**RE: W.O. 22-: West End Intake/Pump Station  
City of Billings Public Works Department, Billings, Montana**

**ADDENDUM NO. 3**  
**TO**  
**CONTRACT DOCUMENTS AND SPECIFICATIONS**  
**FOR**  
**W.O. 22-19, WEST END WATER INTAKE/PUMP STATION**  
**FOR**  
**CITY OF BILLINGS, MONTANA**  
**PUBLIC WORKS DEPARTMENT**

Date: November 2, 2022

**11 94 00 - Exhibit A: Intake Screens, Inc.**

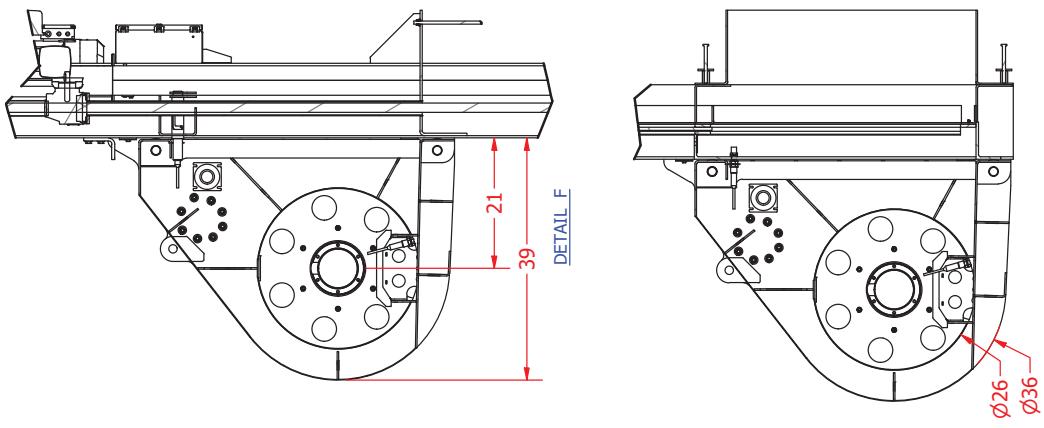
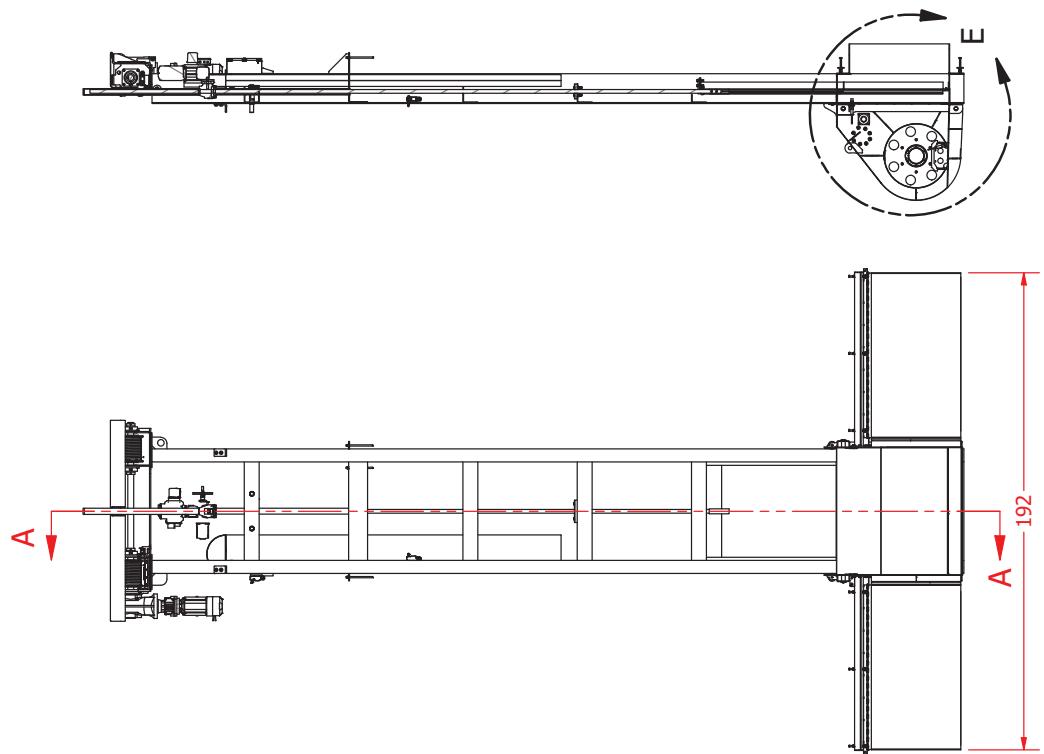
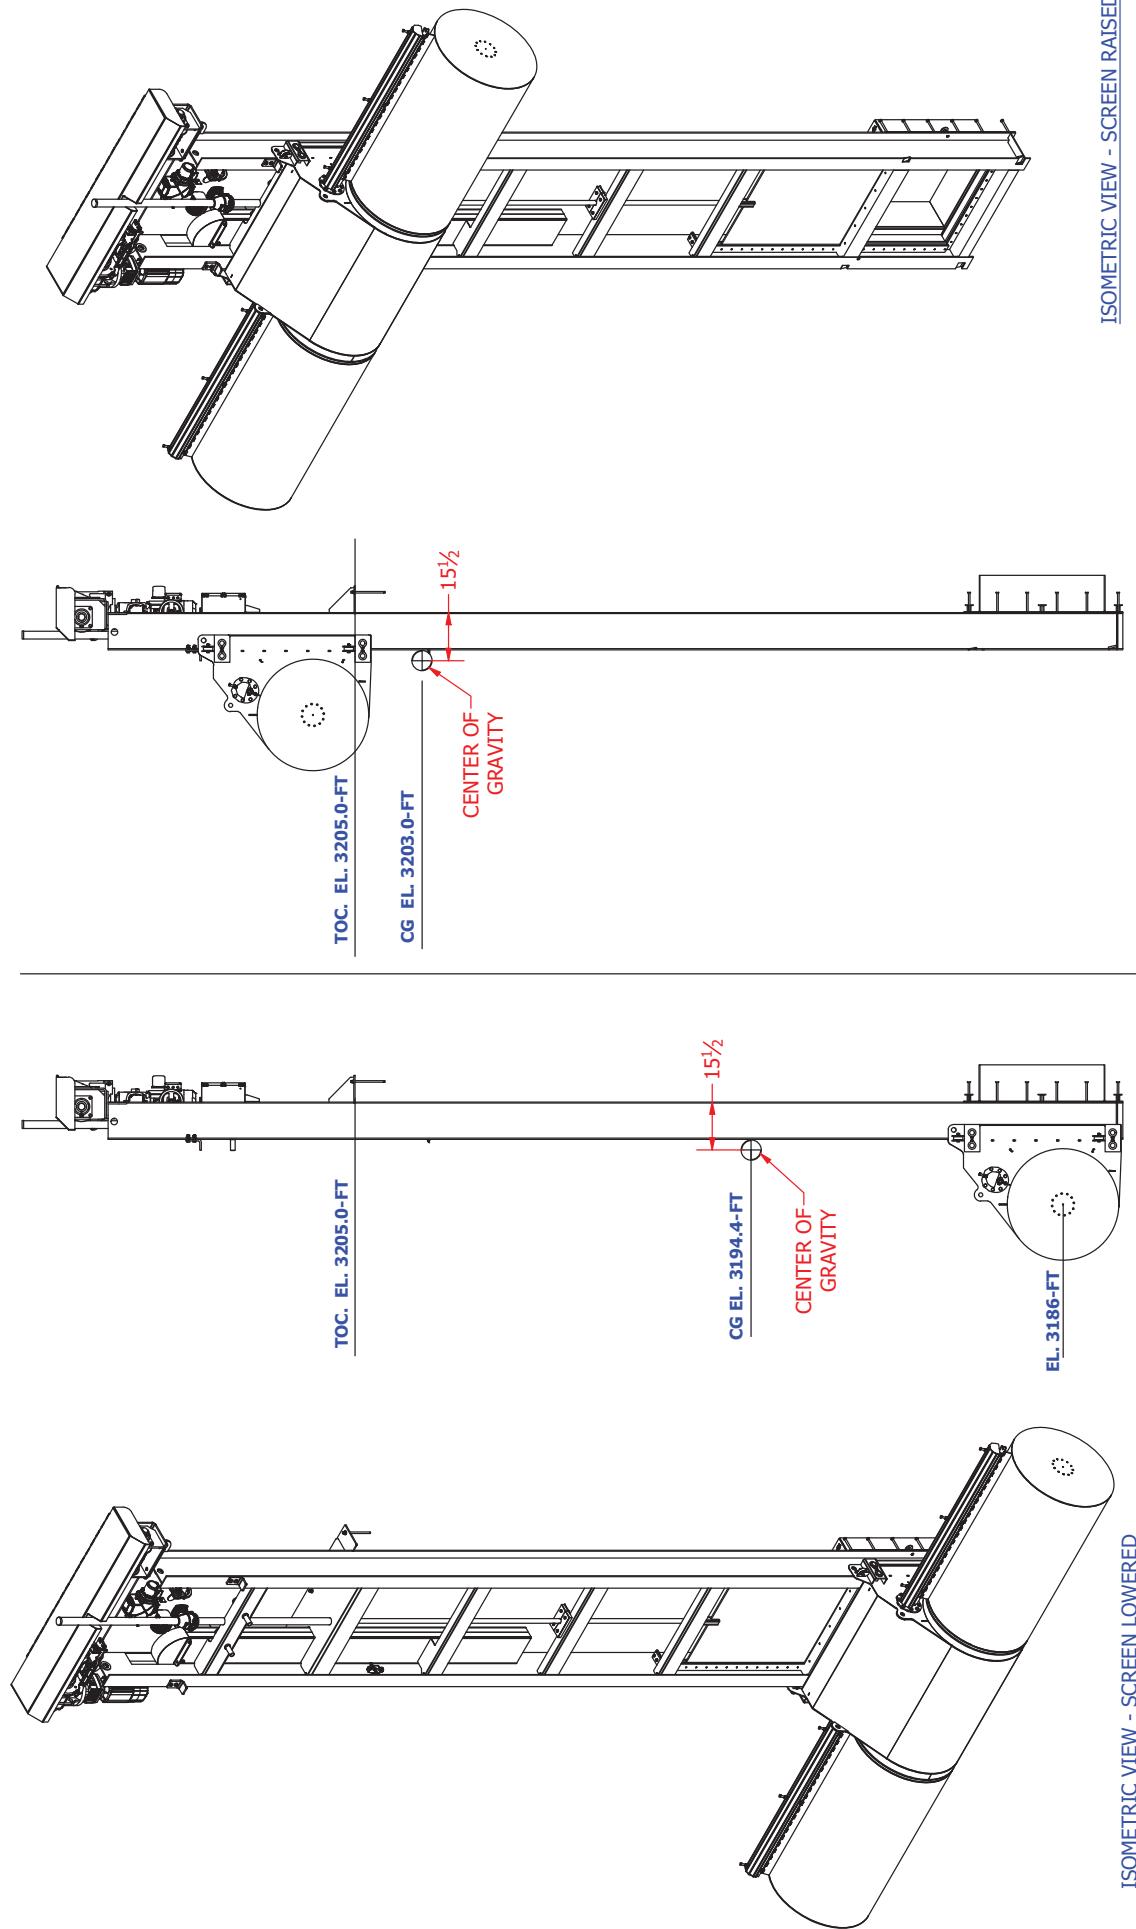
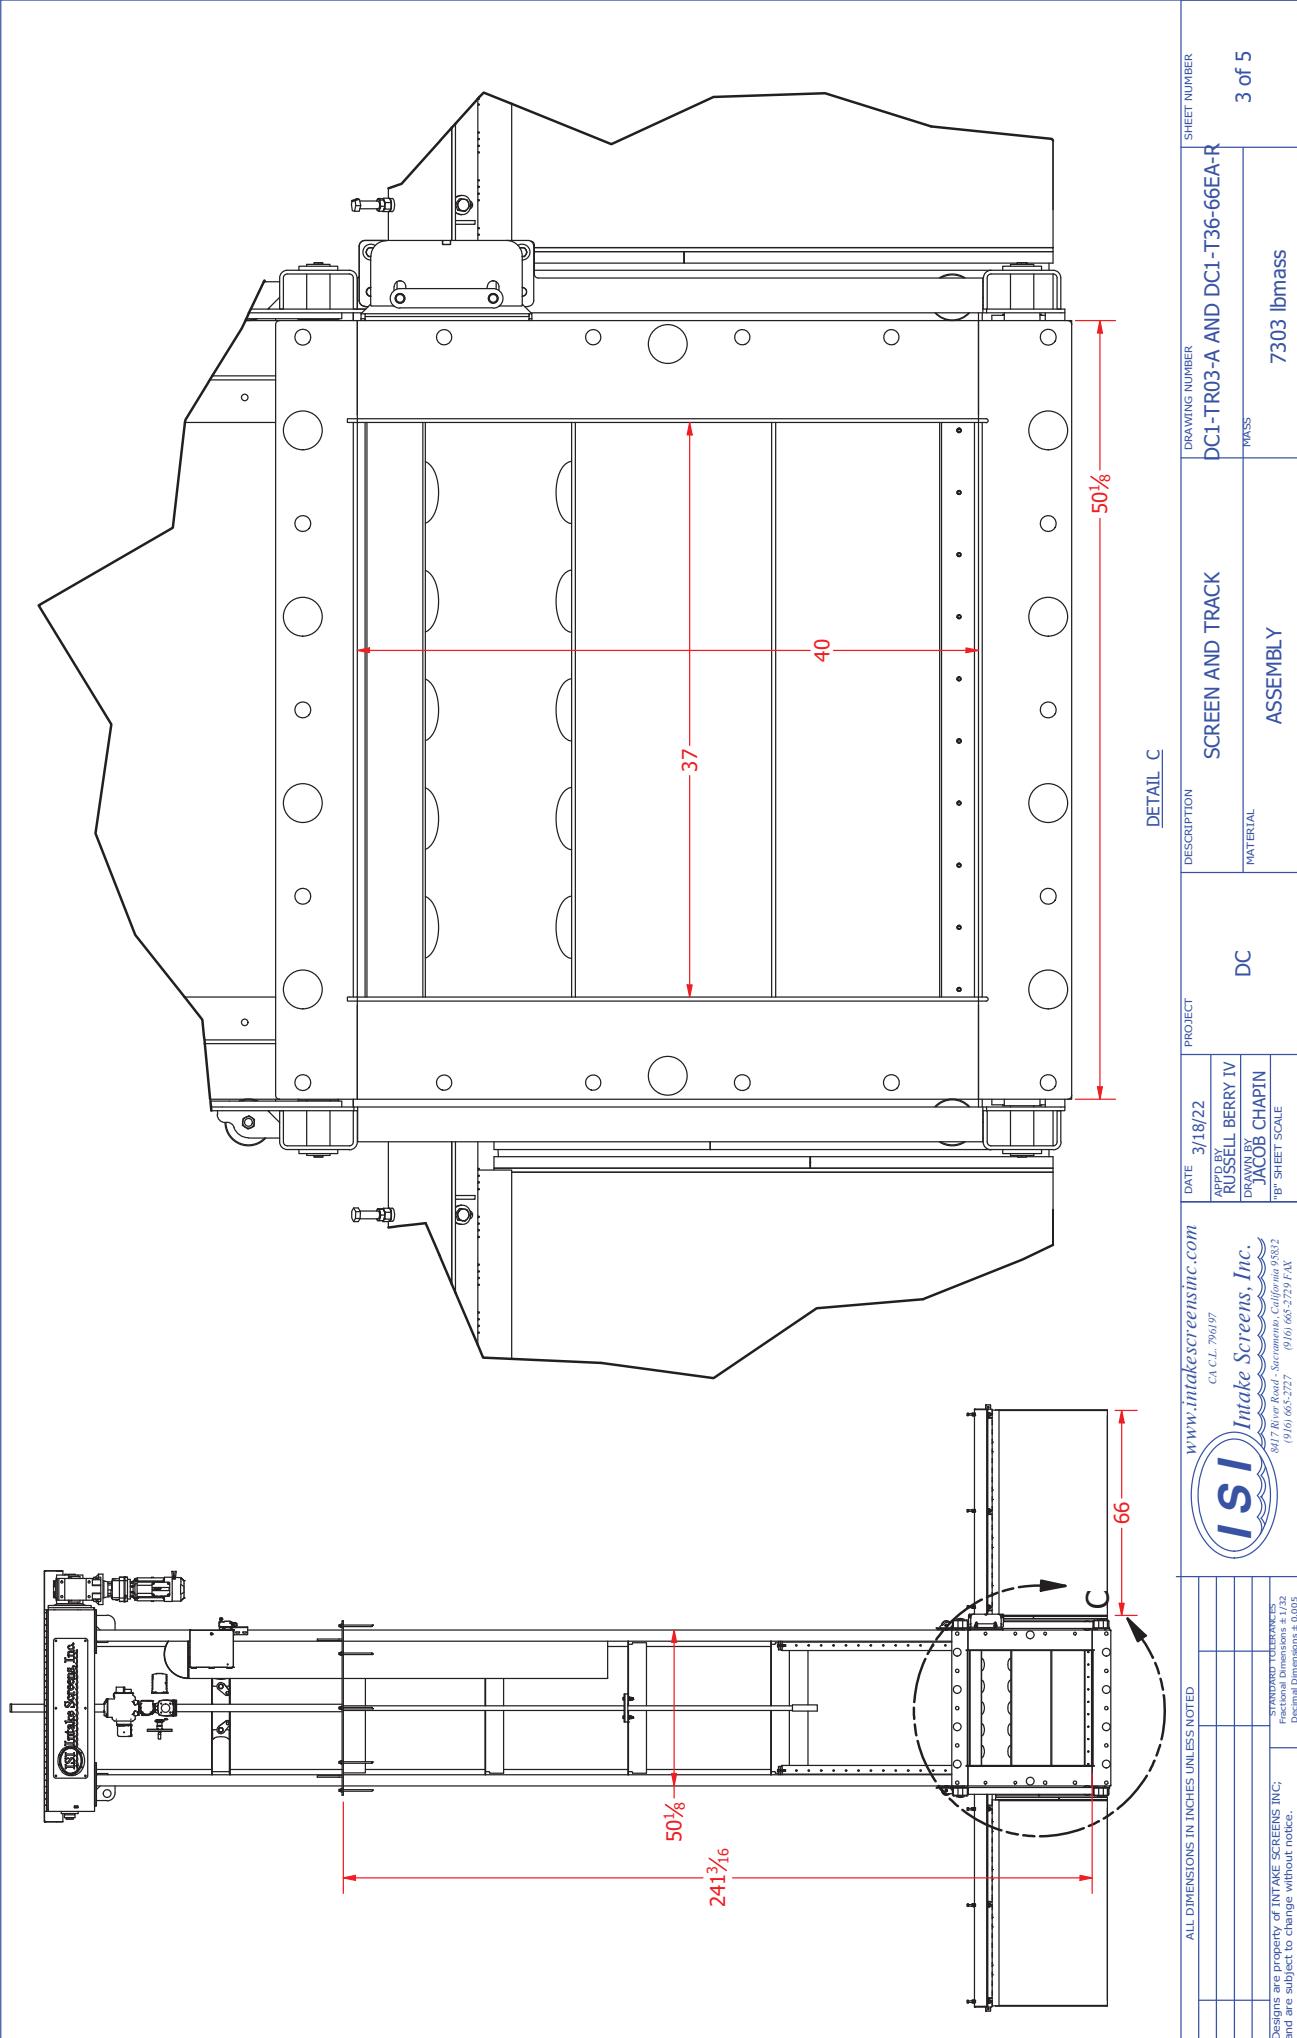
AD-3 Item 9. Section 11 94 00, Exhibit A. DELETE this exhibit in its entirety and REPLACE with the attached 11 94 00 – Exhibit A: Intake Screens, Inc.

**00C007**

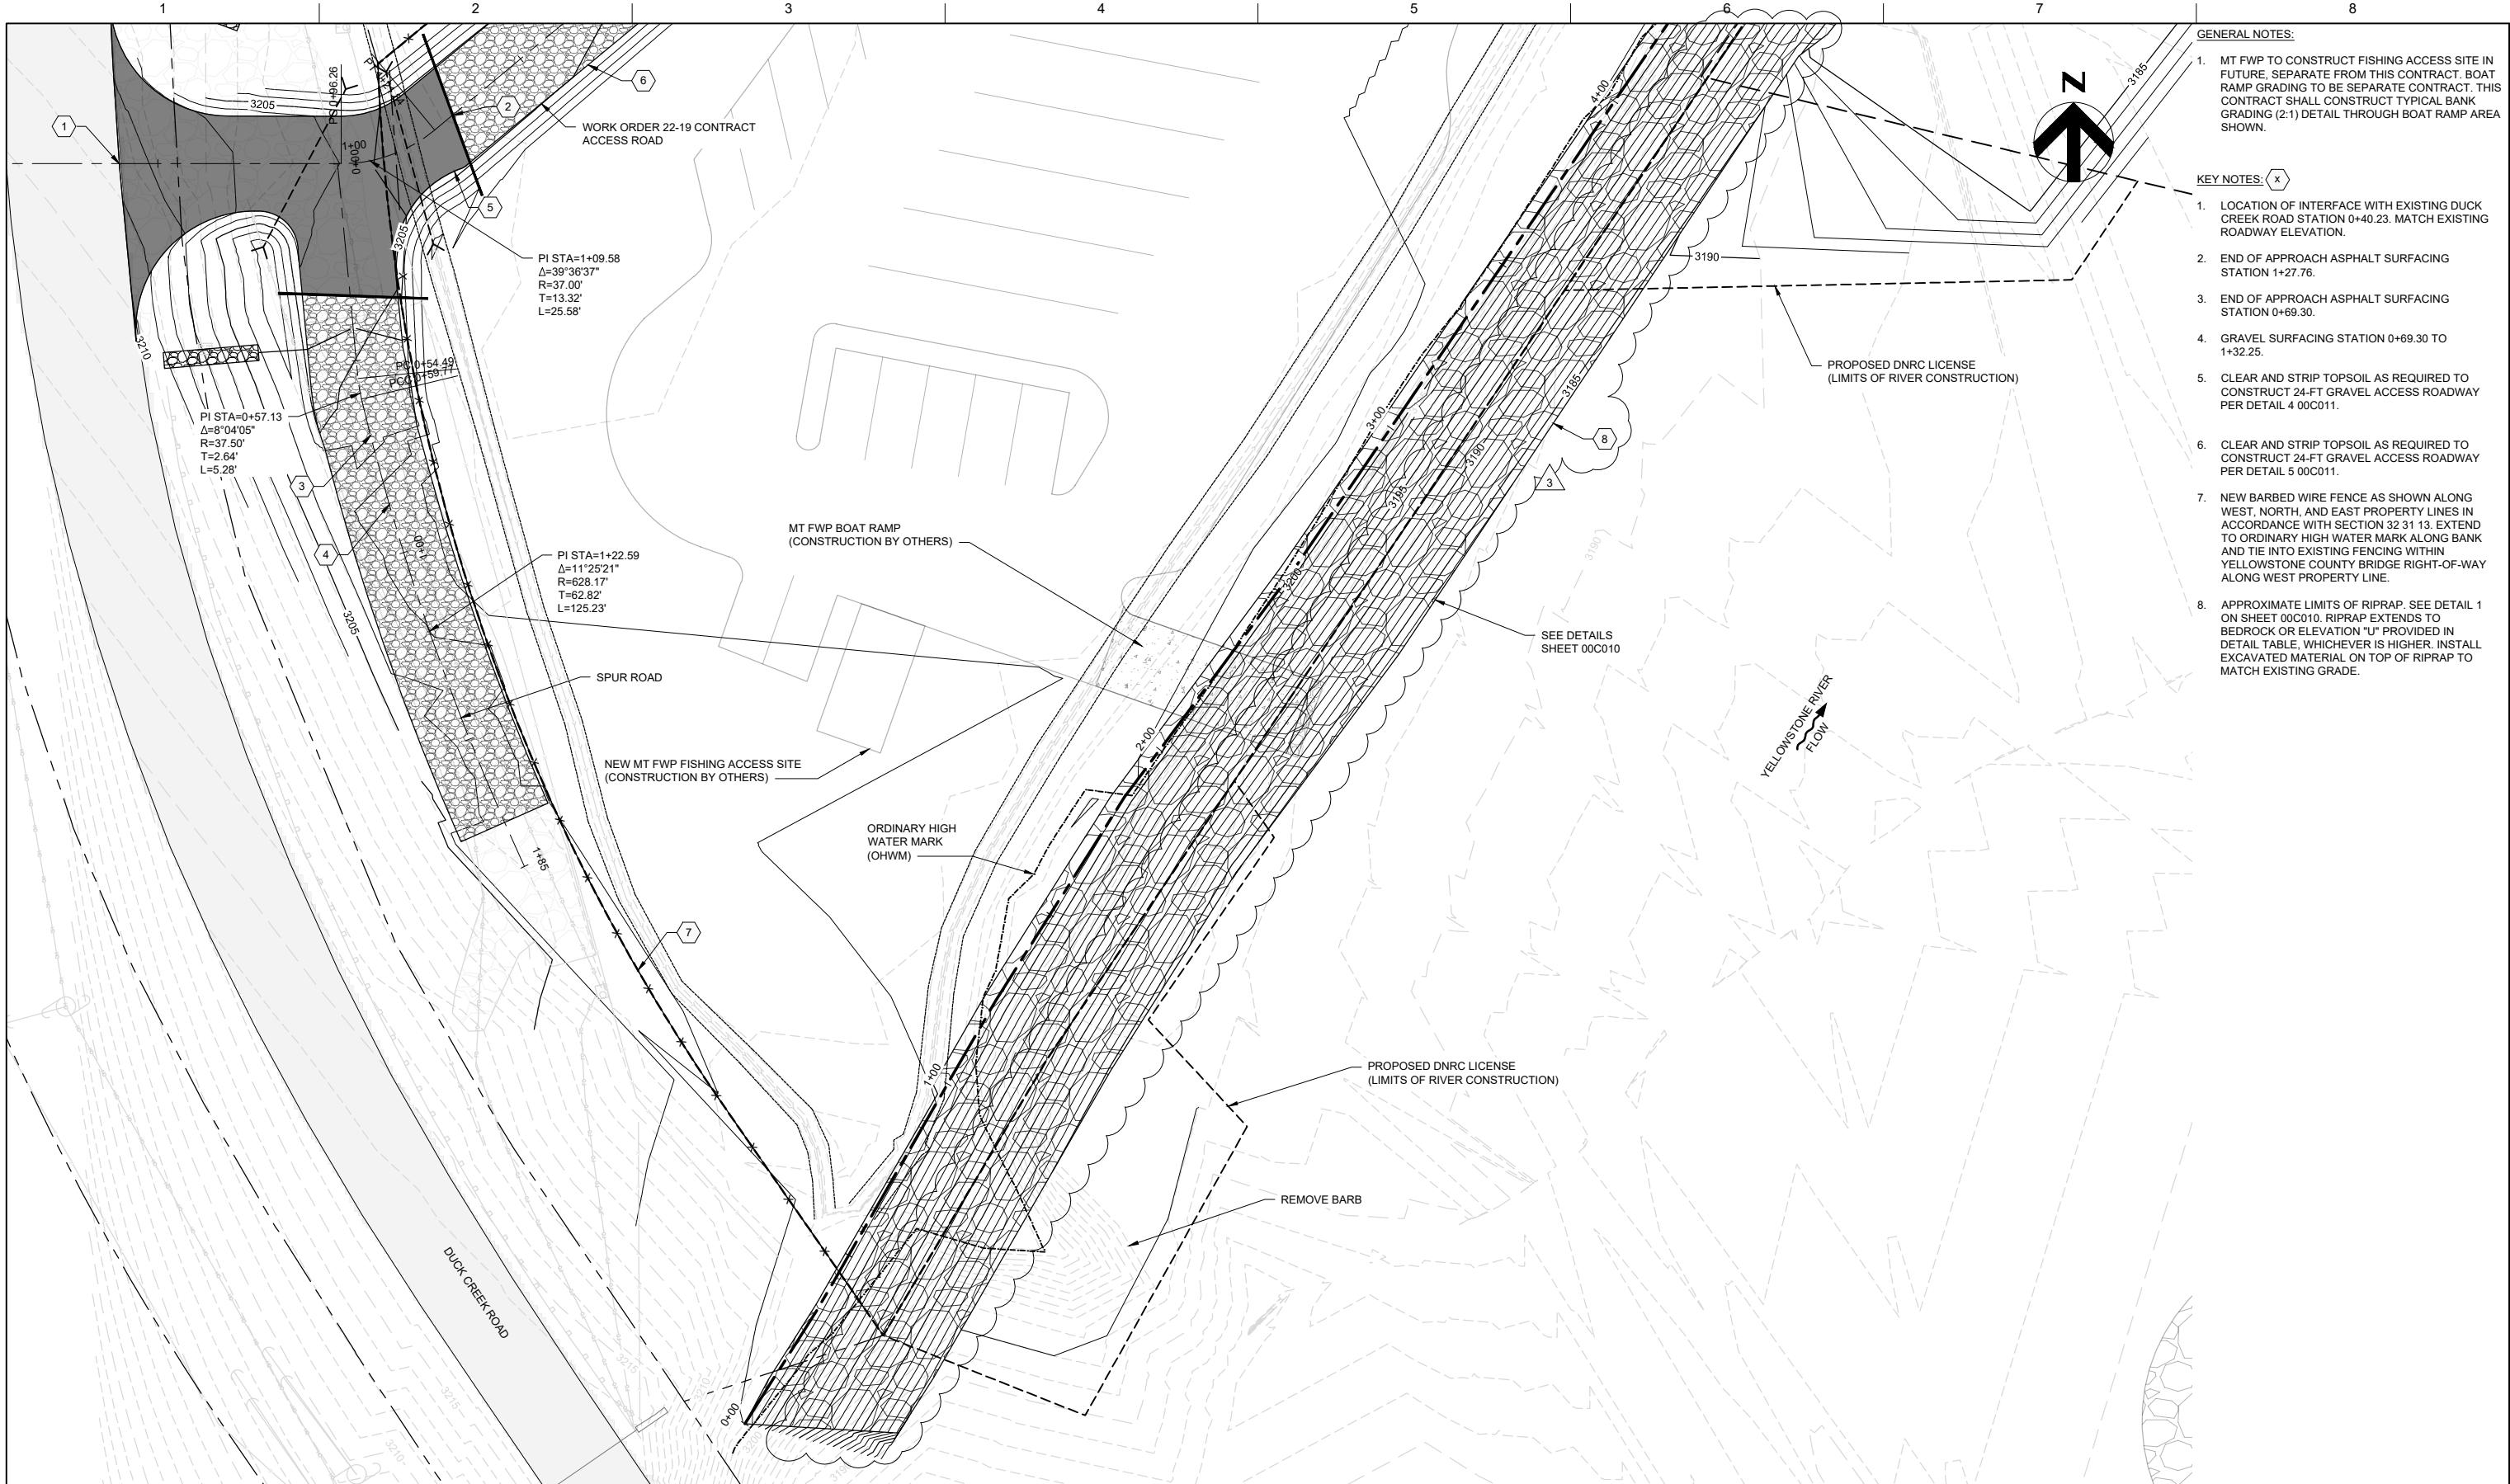
AD-3 Item 16. Sheet 00C007. DELETE this sheet in its entirety and REPLACE with the attached sheet.
